**Dye Branch II  
Stream Restoration  
Post-Repair Monitoring Report (2017)  
NCDMS Project Number: 92255**

**Submitted to  
North Carolina Division of Mitigation Services  
North Carolina Department of Environmental Quality  
February 2018**

Subject: Dye Branch Stream Restoration Project #92255 – 2017 Post-Repair Monitoring Report Comments

**Cross-Sections:**

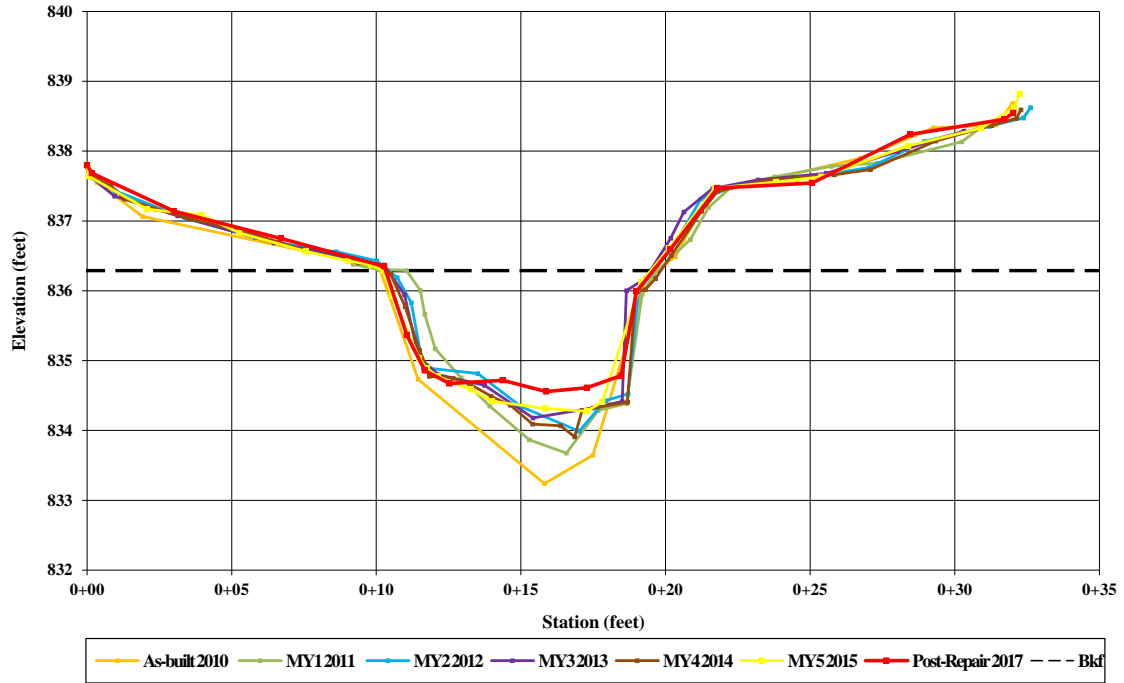
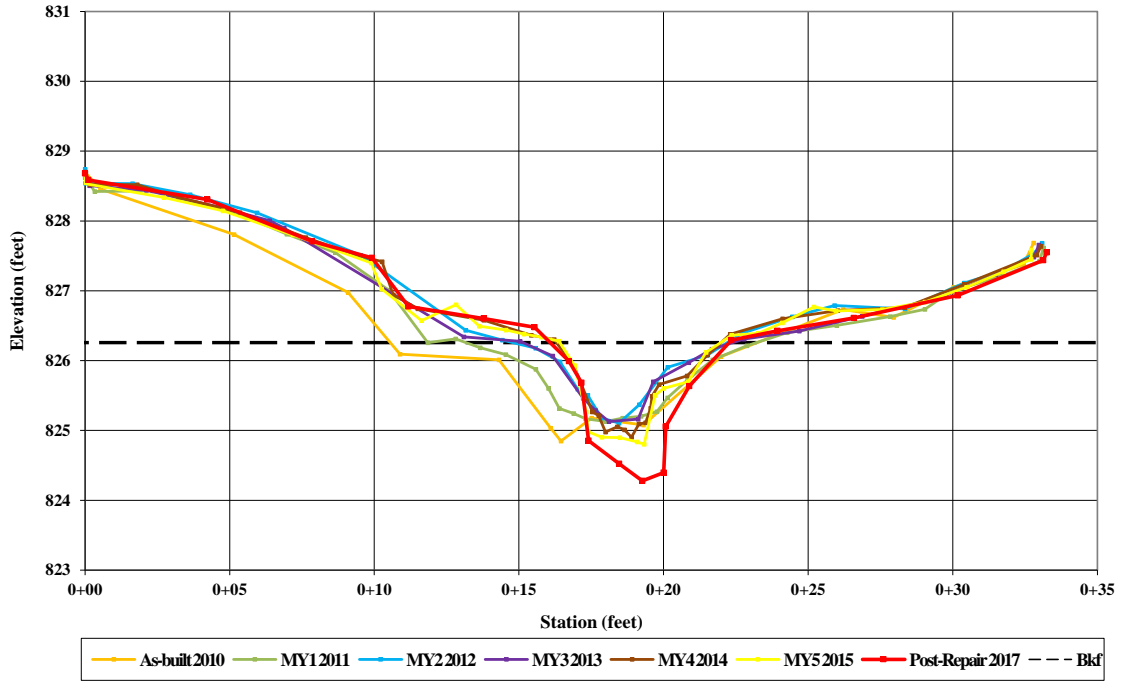
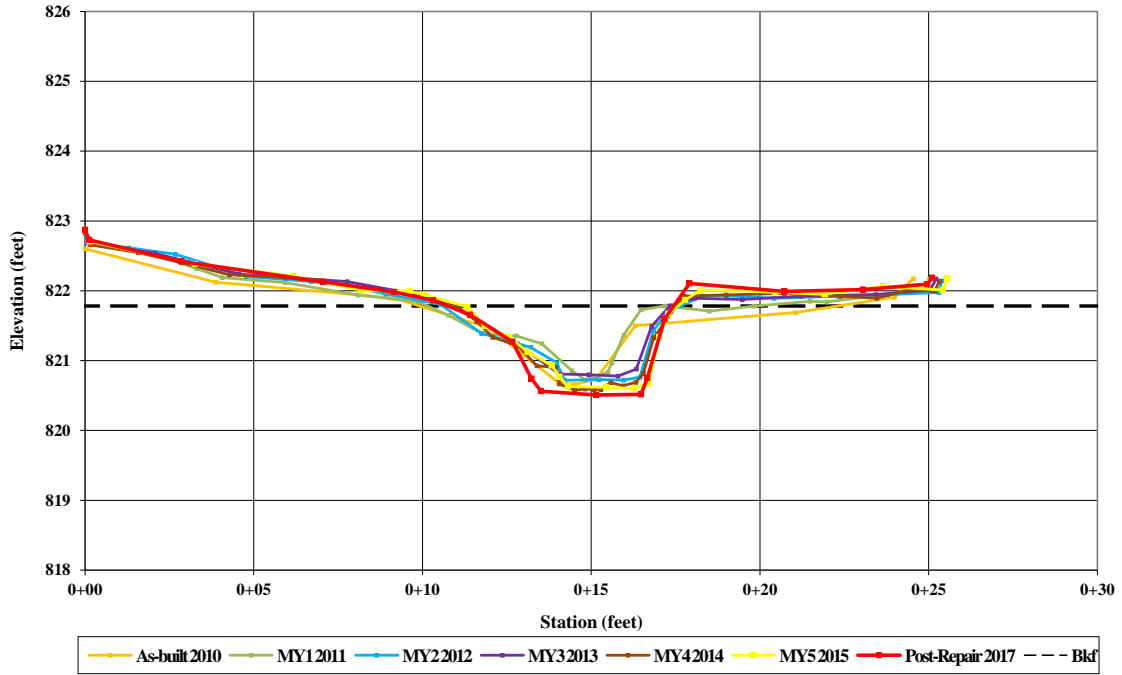
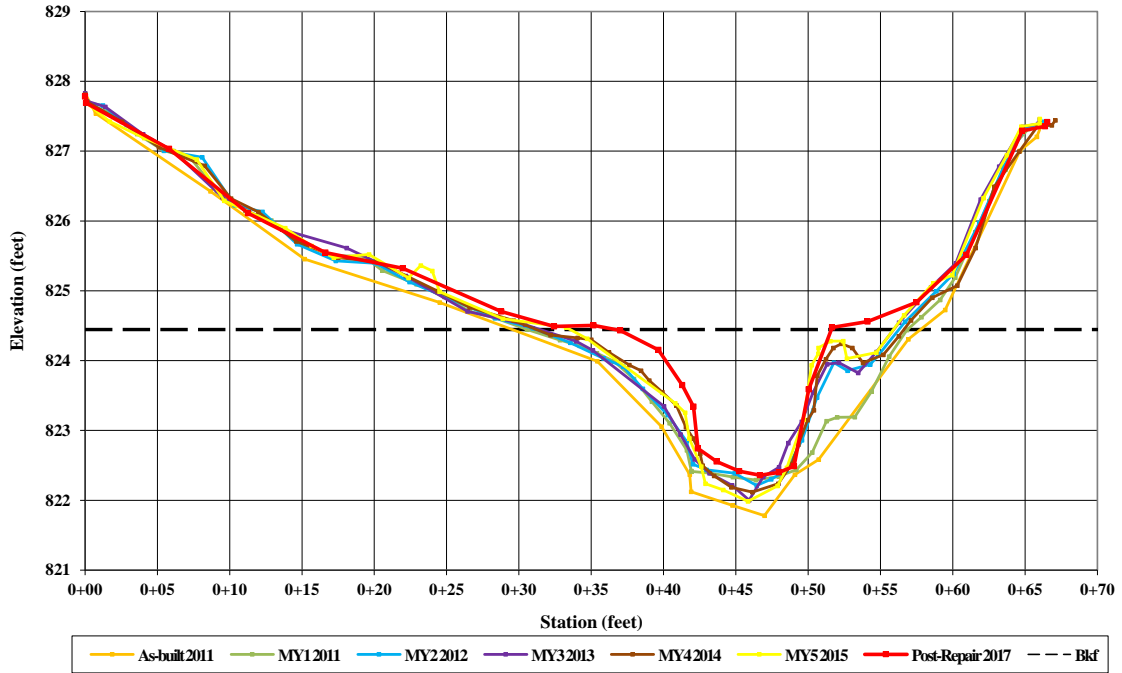
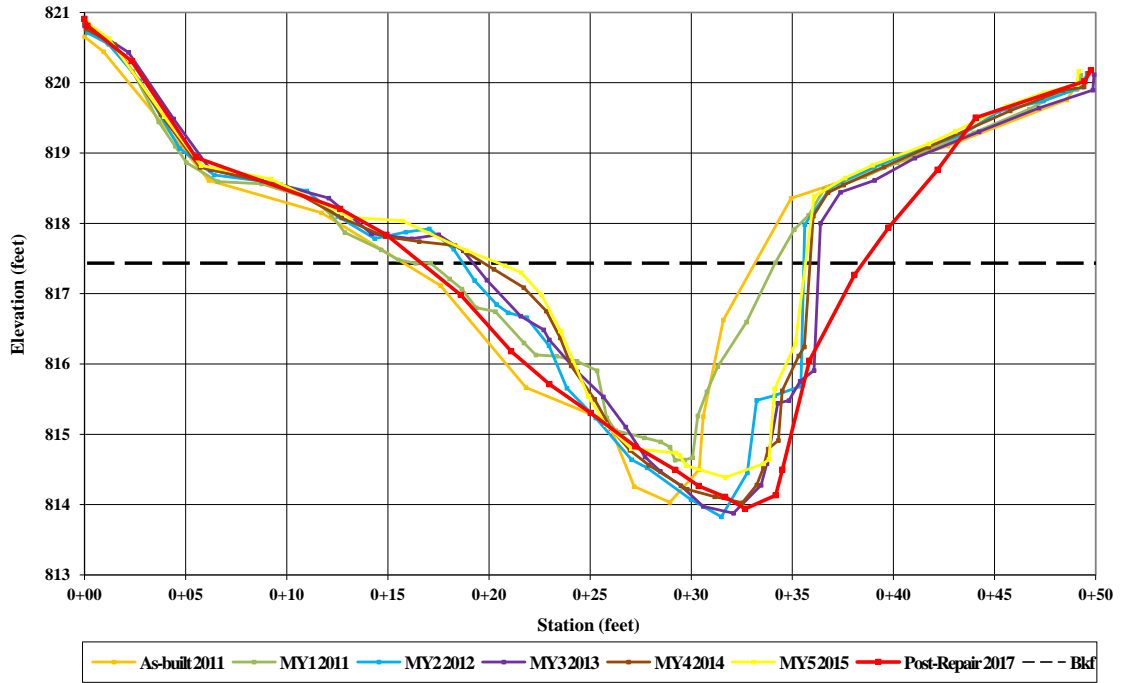
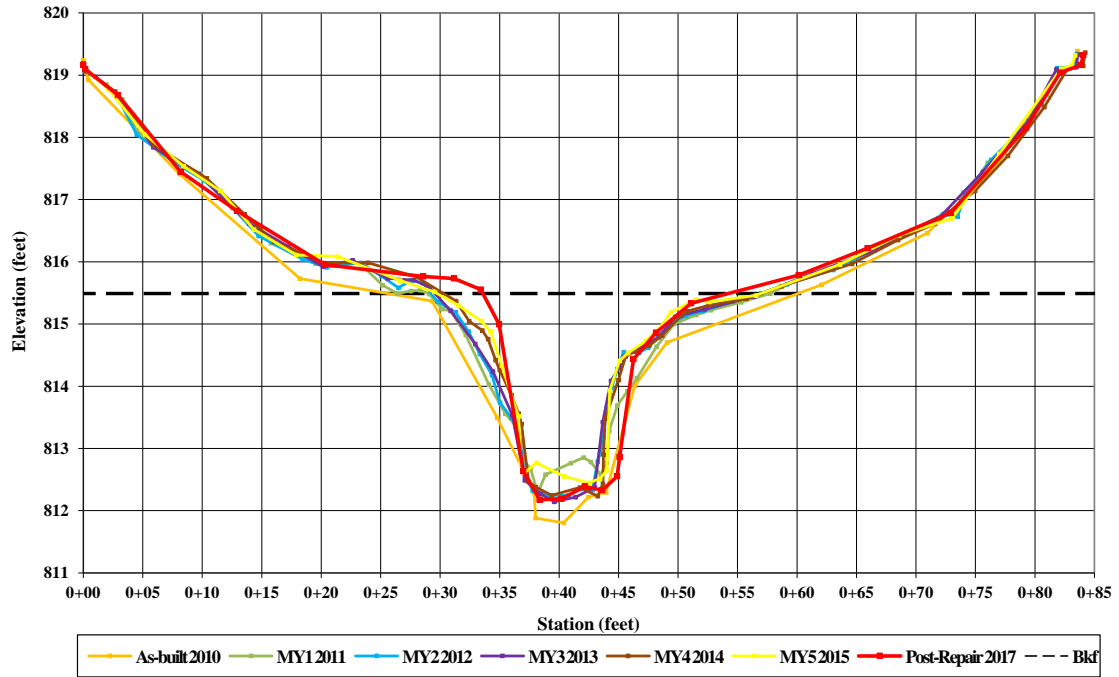
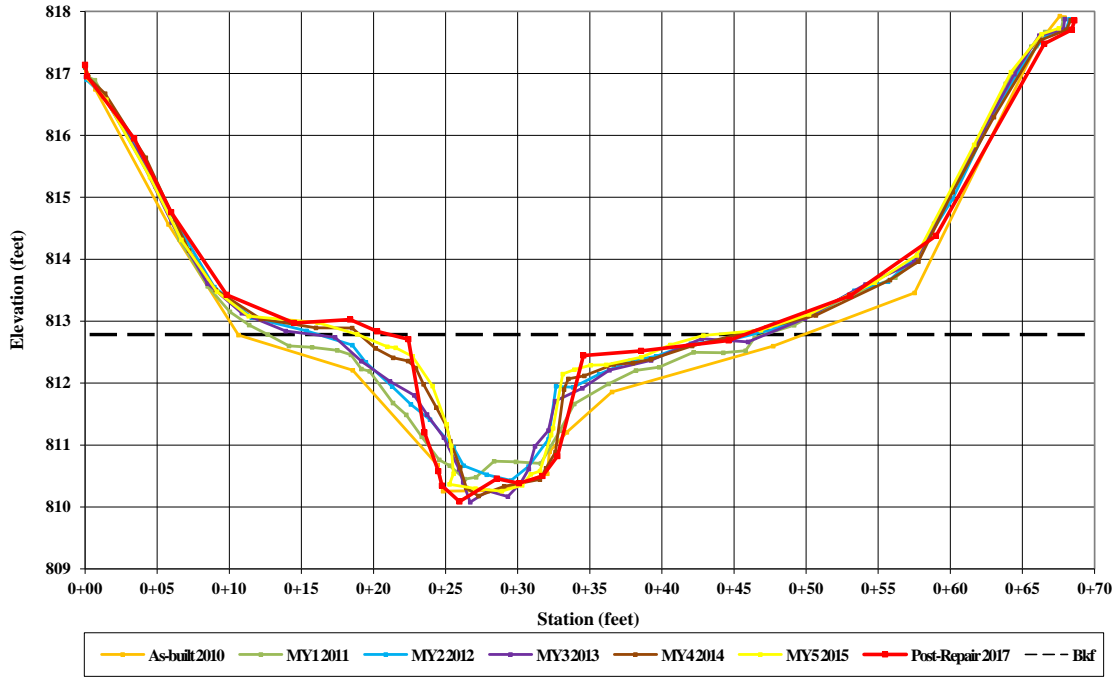
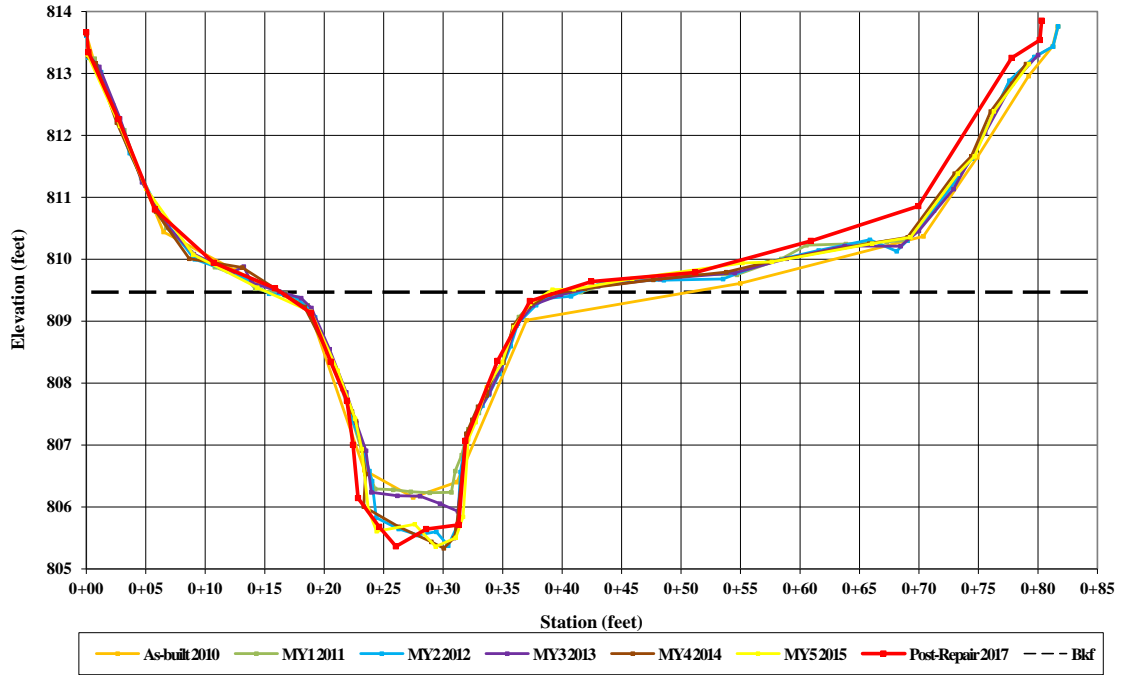
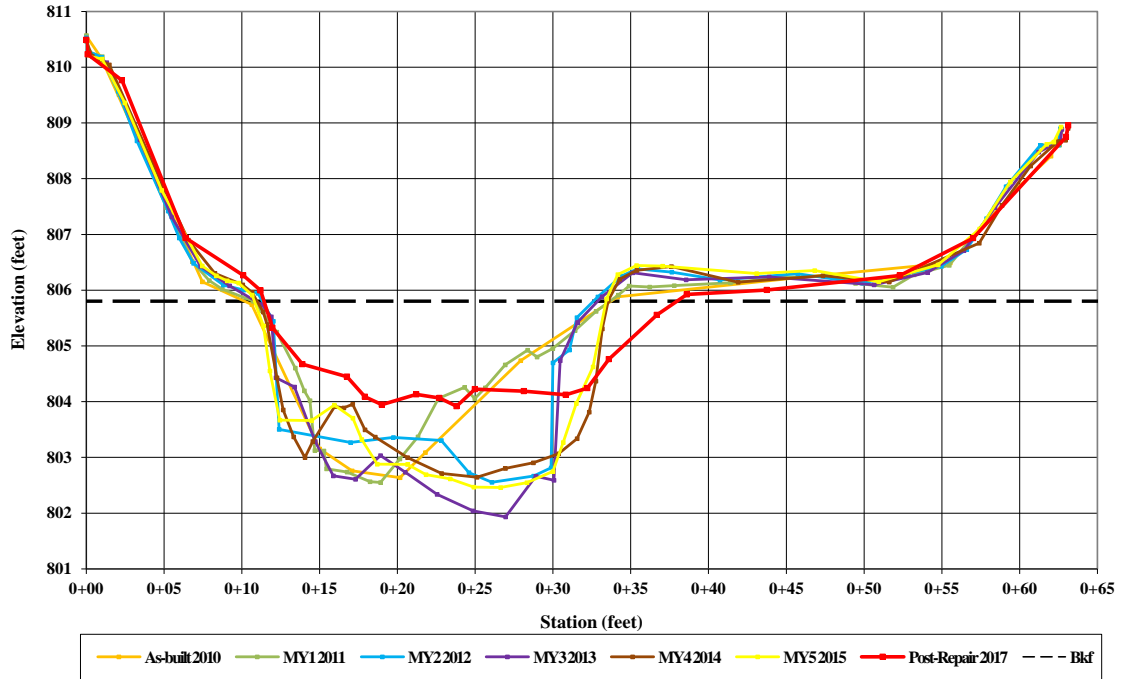
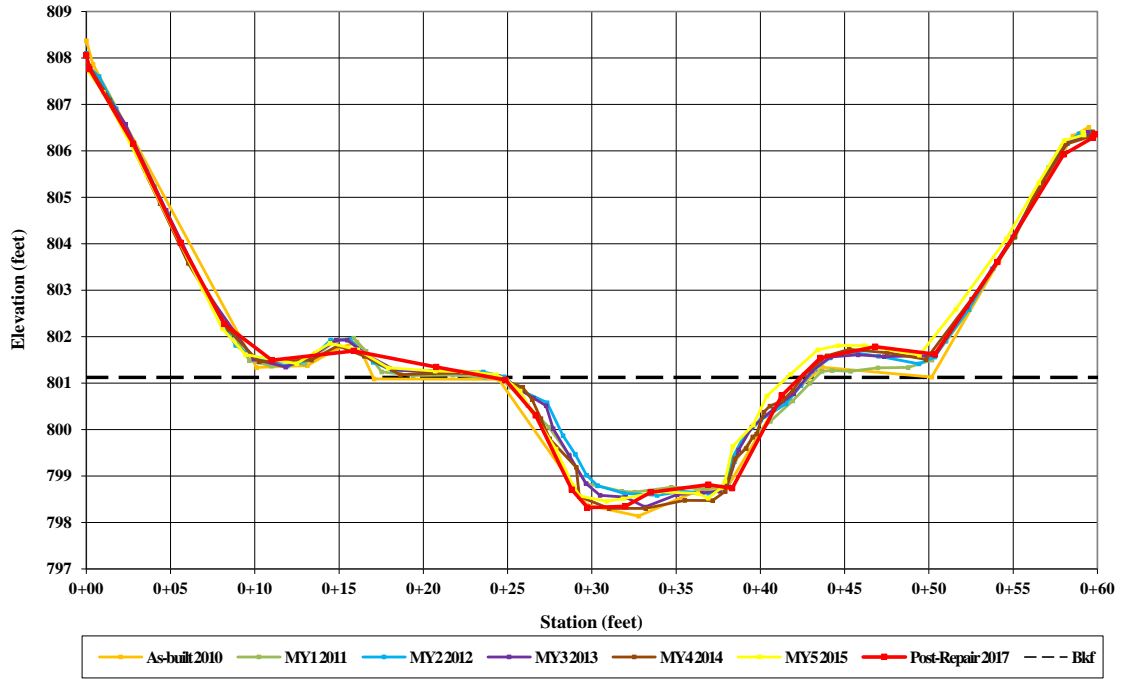
- Please change “Post-Repair 2018” in legend to 2017 in all graphs. **All graphs have been updated to “Post-Repair 2017.”**
